# Access Compliance Report

## Public Rights-of-Way

Intersection ID: 46769	Main Street: MCALLISTER_DR	Cross Street: COLEMON_KERRY_DR	Location: SW
ADA ID: DC62DDED6674	Ramp Type: PerpDiag	Initial Pass/Fail: Fail	Overall Compliance: No
Severity Score: 46.25			
Codes/Mitigation Info/Possible Solution		Field Measurements/Component Compliance

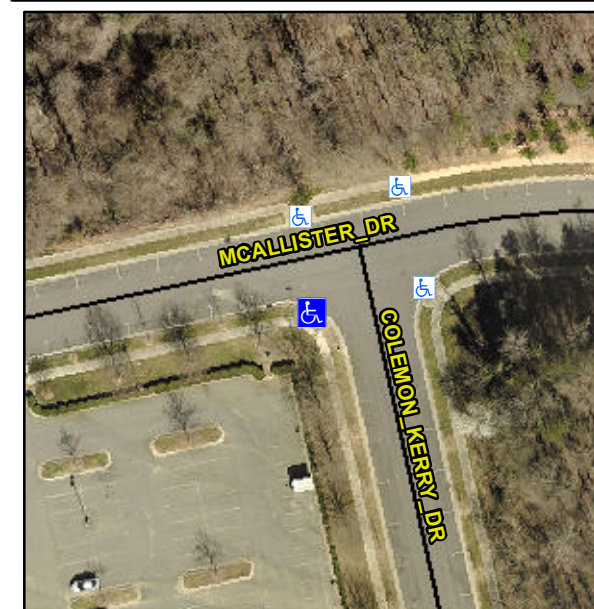
**Not Found, R304.5.1, R304.2.2, R304.5.3**

Compliance	Description	Data	Compliance	Description	Data
N/A	Ramp Length (in)	73.5	No	Ramp Slope (%)	10.6
No	Ramp Width (in)	38.5	No	Ramp XSlope (%)	8.1
N/A	Flare Type LT	N/A	N/A	Flare Type RT	N/A
N/A	Flare Slope LT (%)	N/A	N/A	Flare Slope RT (%)	N/A
N/A	Flare Traversable LT?	N/A	N/A	Flare Traversable RT?	N/A
N/A	Landing Length (in)	N/A	N/A	DWS Provided?	N/A
N/A	Landing Width (in)	N/A	N/A	DWS Contrast?	N/A
N/A	Landing Slope (%)	N/A	N/A	DWS Length (in)	N/A
N/A	Landing X Slope (%)	N/A	N/A	DWS Full Width?	N/A
N/A	Landing Curb? (Y/N)	N/A	N/A	DWS Offset (in)	N/A
N/A	Shared Landing?	N/A			
N/A	Gutter Ponding?	N/A	N/A	Gutter Slope (%)	N/A
N/A	Gutter Lip Ht (in)	N/A	N/A	Gutter X Slope (%)	N/A
N/A	Painted X Walk1?	No	N/A	Painted X Walk2?	No
	X Walk 1 Direction	To E		X Walk 2 Direction	To N
N/A	X Walk 1 Width (in)	N/A	N/A	X Walk 2 Width (in)	N/A
	X Walk 1 Slope (%)	0.2		X Walk 2 Slope (%)	2.6
	X Walk 1 X Slope (%)	3.5		X Walk 2 X Slope (%)	5.0

**Remove & Replace Curb Ramp With Two New Directional Ramps or Equivalent.**
